Mason Dam Hydroelectric Project
FERC No. P-12686

DO Compliance Plan

April 29th, 2013

RE: ODEQ Comments to the DO Compliance Plan (October 2010)
Mason Dam Hydroelectric Project (FERC No. P-12686)

FIGURE 2: GENERAL SPECIFICATIONS OF ROCK WEIRS

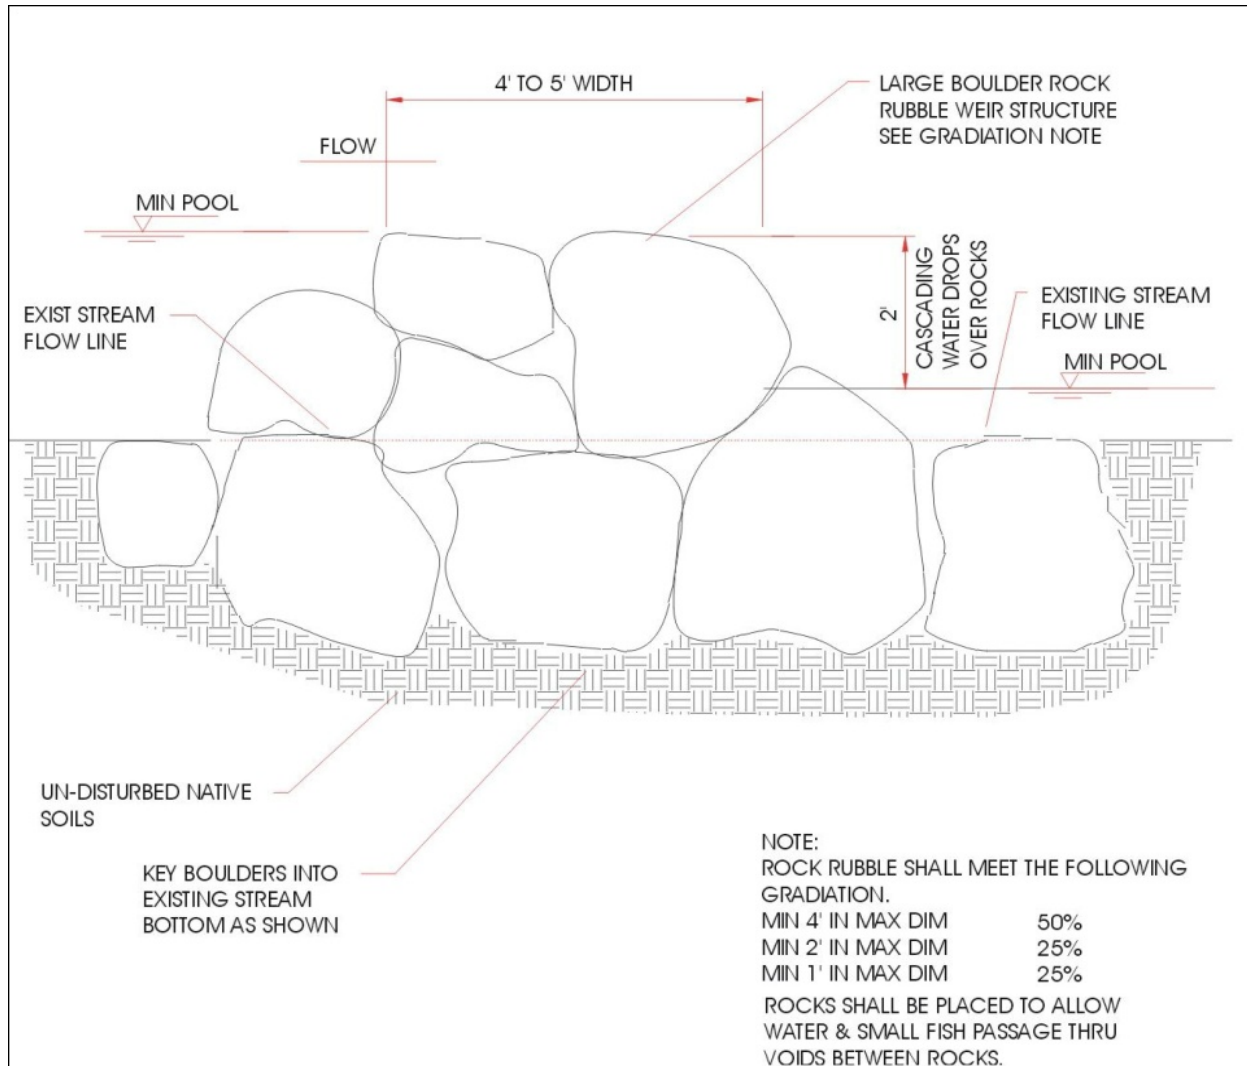
5.1.2 Rock Weirs: Include an analysis of potential impacts to sediment erosion and sediment geomorphology that supports the designated fish use and associated water quality criteria.

5.1.2.2 - Baker County indicates that it will build rock weirs, as needed, across the Powder River in the 0.16 mile stretch downstream of the stilling basin, if agreed upon. Additional information is needed on the potential effects of these weirs on stream flows, fish passage, entrapment and stranding, and erosion. Upstream and downstream passage of all life stages of native migratory fish species, which include redband trout, needs to be provided throughout this stretch of the Powder River.

5.1.2.4 – As proposed, weirs would be constructed one at a time until their number is sufficient to achieve the standard at the monitoring station. Additional information is needed on monitoring that will occur and how the project will be operated during weir construction to ensure water quality standards are met.

5.1.2.5 – ODFW believes that state water quality standard for DO will need to be met at the downstream end of the stilling basin. According to Attachment 7.1, however, three rock weirs would be placed within the 0.16 mile section of the Powder River downstream of the stilling basin. Therefore, the state standard for DO would not be met at the downstream end of the stilling basin. If DO standards cannot be met at the downstream end of the stilling basin with installation of rock weirs, ODFW recommends that other alternatives be investigated that would provide a reasonable assurance of compliance with state water quality standards. Further, how were locations and numbers of weirs determined?

5.1.2.8 – Baker County indicates upstream passage for small fish will be provided through large interstitial passages between boulders. Oregon's fish passage law (ORS 509.580 - 509.645) requires upstream and downstream passage at all artificial obstructions in those Oregon waters in which migratory native fish are currently or have historically been present. Additional information needs to be provided to demonstrate that upstream and downstream passage will be provided throughout the year for all life stages of native migratory fish. This should include a discussion of how interstitial spaces will be maintained. Rock weir designs should be provided to ODFW for review and approval. No construction should occur until ODFW approves rock weir designs.

5.1.2.9 – Construction is proposed for minimum flow periods. Construction will need to occur during ODFW's instream work window, unless a variance is requested and approved by ODFW.

General specifications of rock weirs can be found in Figure 2. Weirs would create a step under 2 feet high at all but minimum flows. Rock rubble sections will allow small fish to traverse the weir through large interstitial passages between boulders. Construction will be performed during minimum flow periods. Cofferdams will be used to dewater half the stream channel during weir construction. The in stream work window occurs from July 1 – October 31 for the Powder River from the mouth to Phillips Reservoir. All construction will be performed to Oregon State water quality standards with specifications developed for the weirs completed with consulting agencies prior to construction. Procedures outlined in the Erosion and Sediment Control Plan will be followed.
